Service Bulletin

SUBJECT: Special Coverage Adjustment – Coolant Leak / Drip on Automatic Transmission Shifter Grommet

MODELS: 2011-2012 Chevrolet Cruze
Equipped with 1.8L (LUW) Engine and 6-Speed Automatic Transmission (MH8)

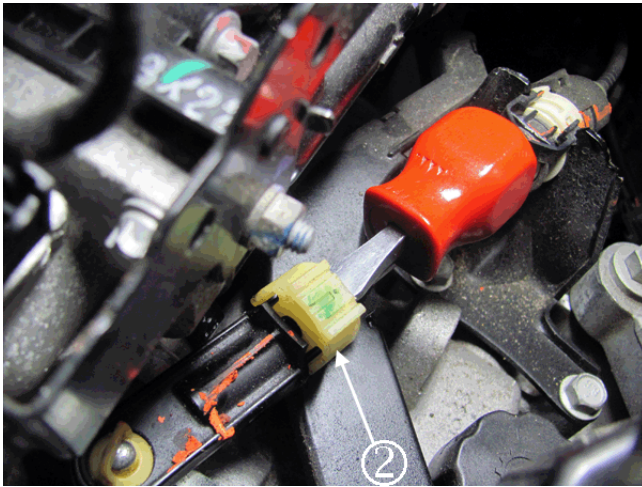
Note: Some customers may comment about a coolant leak or irregular shifter movement. Coolant leaking onto the shifter cable bushing may deteriorate or damage the bushing. The thermostat is in close proximity to the shift cable grommet. If the grommet is damaged or missing, some customers may comment that shifting gears may be hard or feel “loose” with excess play.

1. Determine if the thermostat housing is leaking.
 - If the thermostat housing is leaking, replace the thermostat housing and shift cable adjuster body with lock clip. Refer to *Engine Coolant Thermostat Housing Replacement (LUW)* in SI. Refer to *Shift Cable Adjuster Body and Lock Clip Replacement* in this bulletin.
 - If the thermostat housing is NOT leaking, inspect the shift cable retaining bushing to determine if the bushing is missing or damaged at the connection to the transmission range selector lever. The bushing is on the end of the shift cable adjuster body.
 - If the bushing is damaged or missing, replace the shift cable adjuster body and lock clip.
 - If the bushing is NOT damaged or missing, no further action is required.

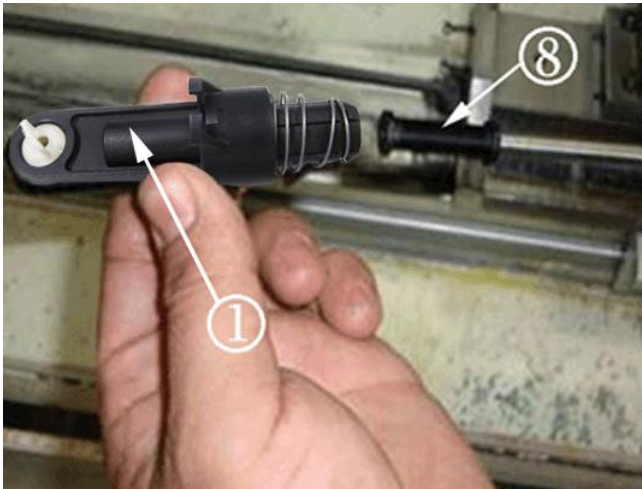
6. Remove the spring (3) inside the adjuster body (1) and insert it into the new adjuster body.
7. Discard the old adjuster body (1).

Note: The new adjuster body (1) has a secondary lock and a spring on the outside of the adjuster body.

4211012

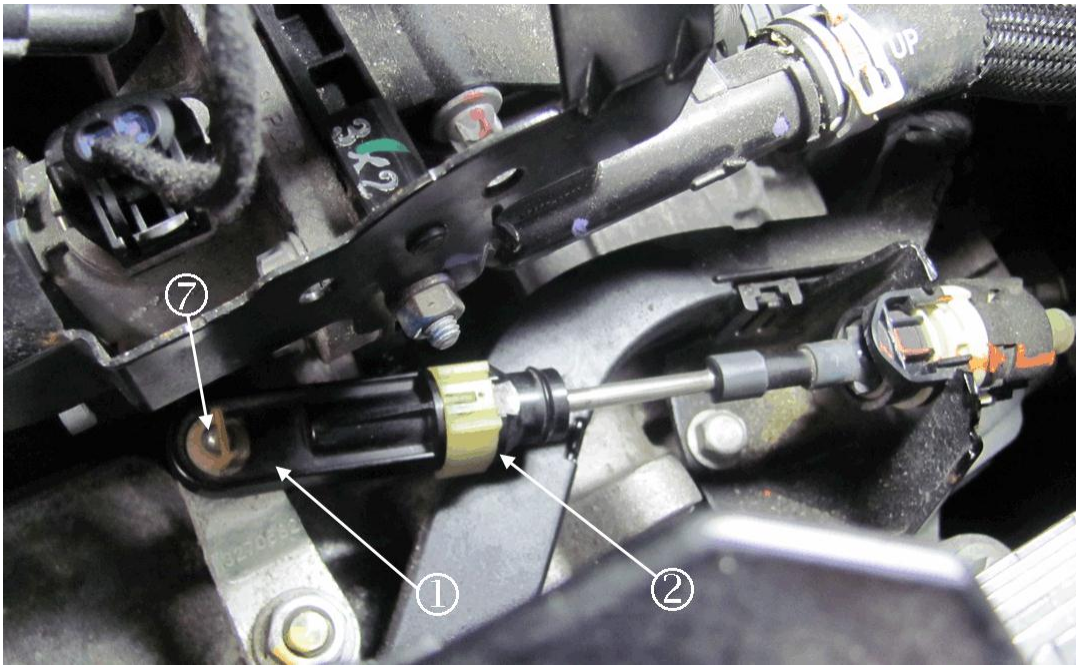
Photograph shown with the secondary lock and outside spring removed to show the white lock clip fully engaged. The top of the white lock clip should be flush with the black adjuster body.
